Manual 07 Update – Revision 5

PJM Protection Standards

Stan Sliwa, P.E.
Transmission Planning
Markets & Reliability Committee
August 20, 2025

Transformer High-Side Lead Protection Examples

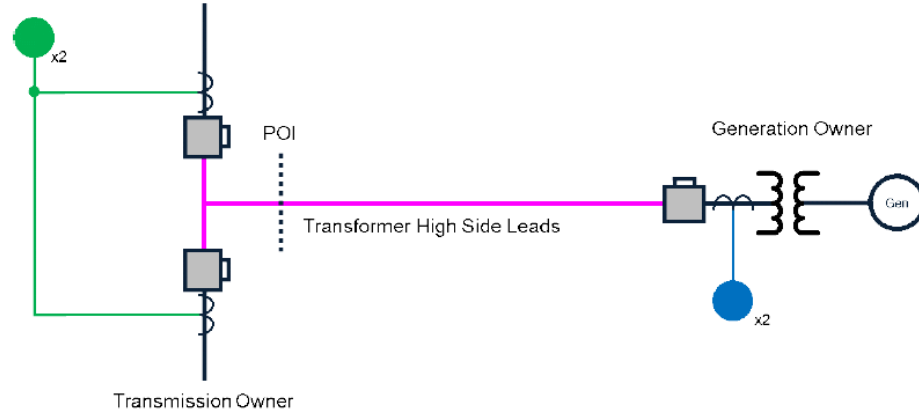
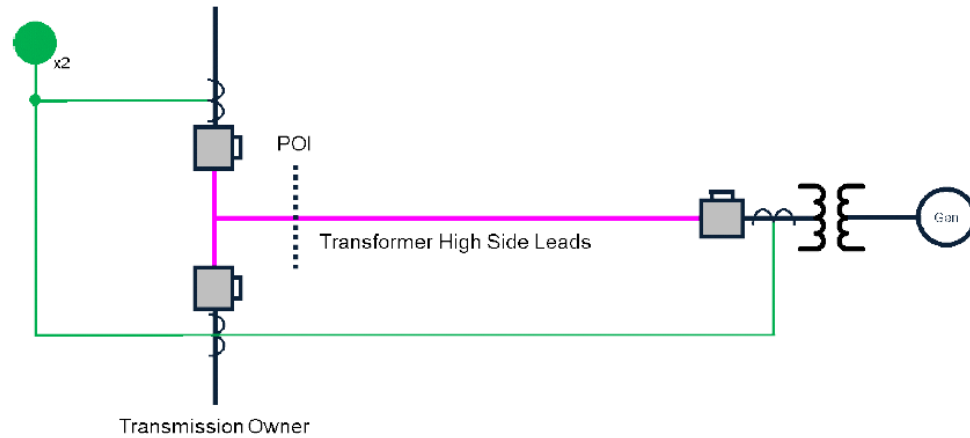
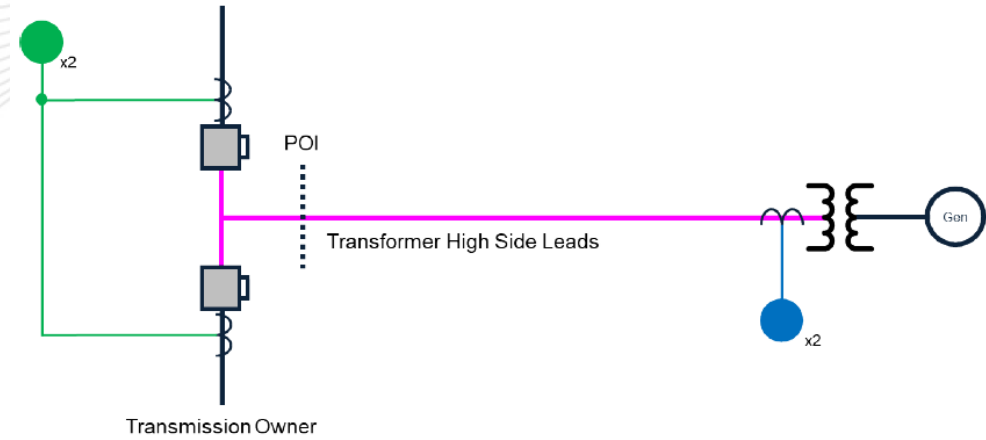
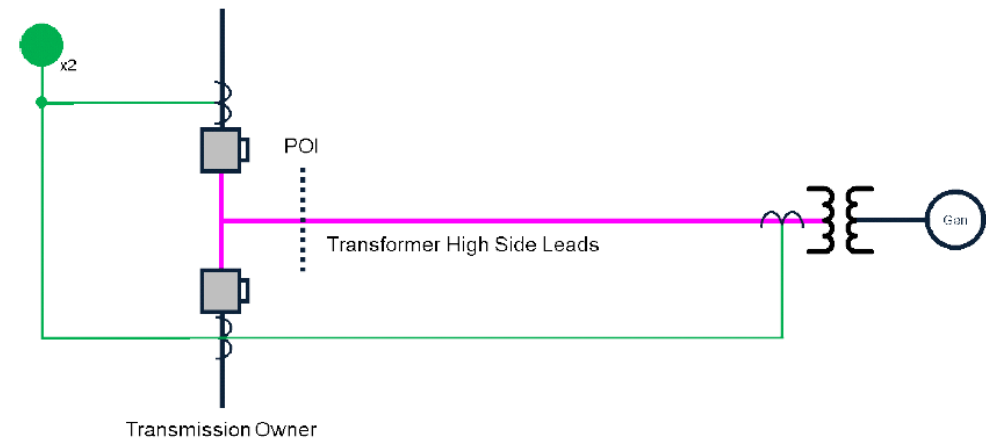
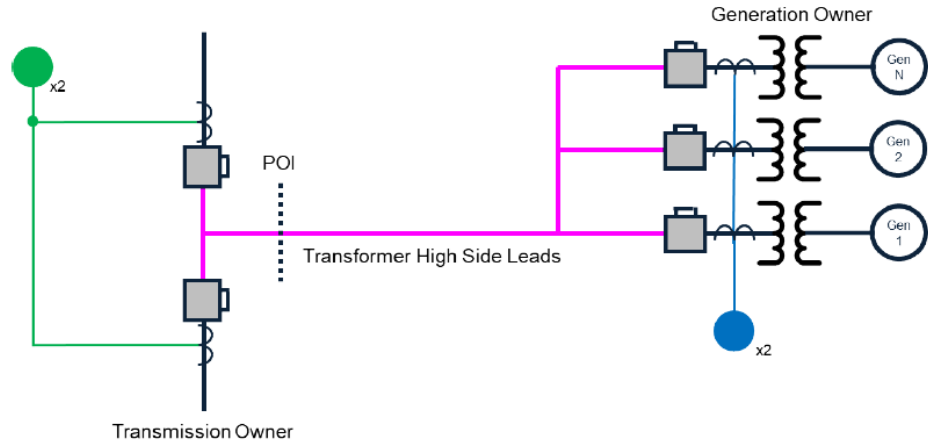
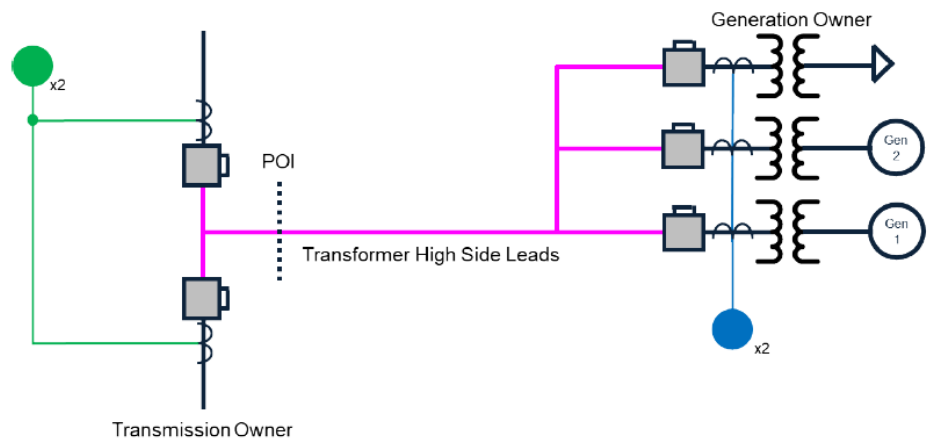
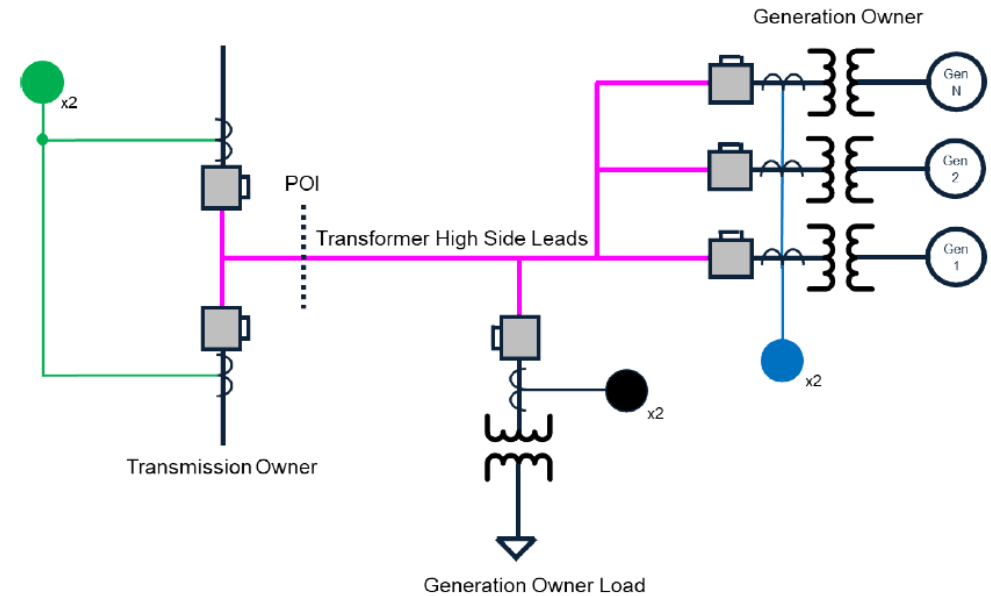
- Enhanced section 4.2 on transformer high-side lead protection with more details and added reference diagrams

In Section 4.2.1 several examples of acceptable configurations are provided; this is not an exhaustive list. Other configurations of both the protection and phase conductor are possible while satisfying the requirements. Additionally, Section 4.2.1 provides a possible system configuration that is prohibited.

The transformer high-side leads are required to be protected by two independent current differential schemes ~~or equivalent high-speed schemes~~. The schemes must utilize independent current sources and independently protected DC control circuits.

Transformer high-side leads shall not have infeed within the protection zone as experienced by the two independent current differential schemes. Transformer high-side leads shall not have more than two terminals as experienced by the two independent current differential schemes.
